23018-01-001

**Proposed Cycle Facilities and  
Junction Improvements at  
Dooradoyle, Limerick.**

**ROAD SAFETY AUDIT STAGE 1**

**August 2023**

### 2.2 Problem

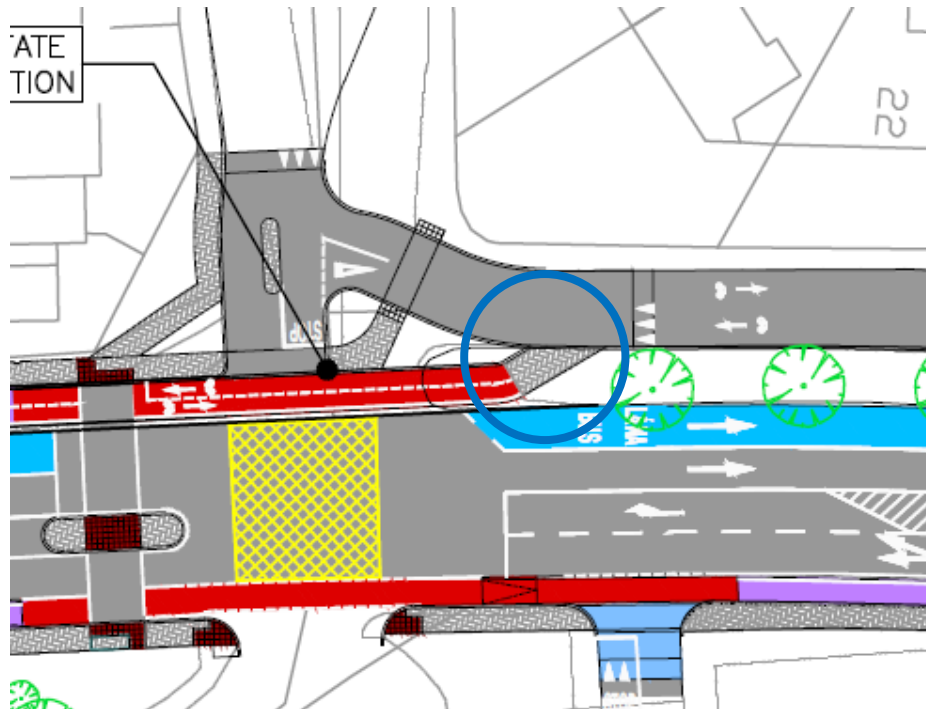
Corduroy tactile paving has not been provided at the pedestrian crossing locations throughout the scheme. This may contribute to pedestrian / cyclist collisions at the crossings.

Tactile paving should be provided.

### 2.4 Problem

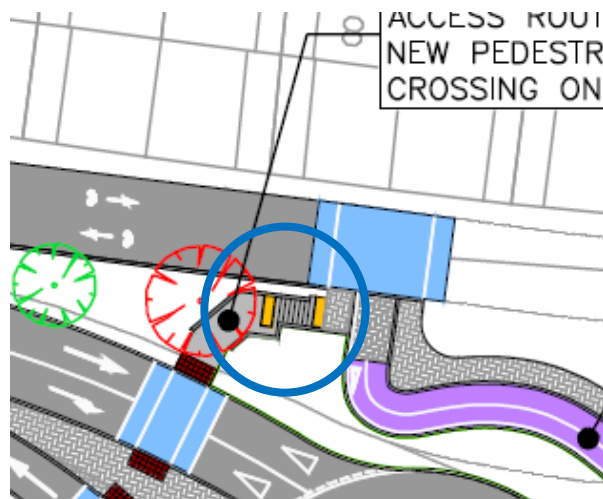
Steps are proposed at a pedestrian access onto Ballykeeffe Estate Rd. Steps pose a risk to visually impaired pedestrians.

Ensure corduroy paving is provided at the top and bottom of the steps to warn visually impaired pedestrians.

## 2.5 Problem

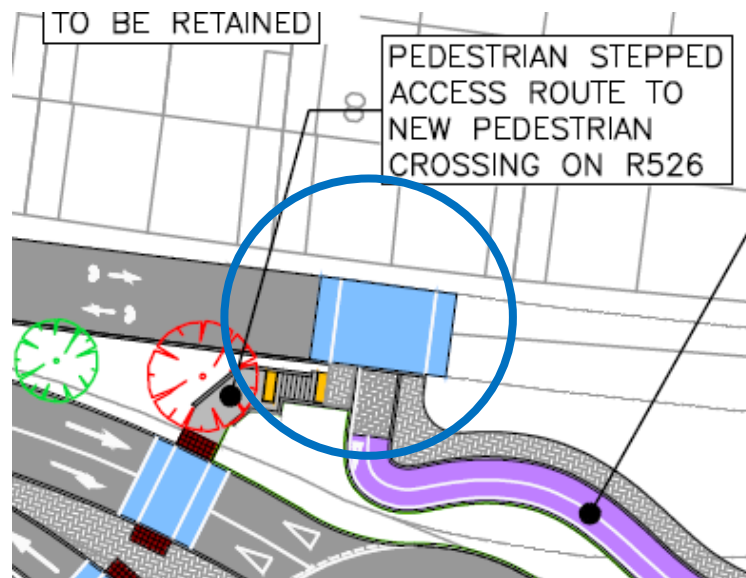
A proposed raised pedestrian crossing is provided on Ballykeeffe Estate Road adjacent to house no. 7 & house no. 8. The crossing is provided adjacent to the vehicular access to both of the houses. It is unclear if a pedestrian has priority or a vehicle entering or exiting the driveway has priority. This may result in conflict between pedestrians using the crossing and a vehicle entering or exiting the driveway which may contribute to a collision between a vehicle and a pedestrian at this location.

Relocate the crossing to ensure it does not conflict with a vehicular entrance to a residential dwelling.
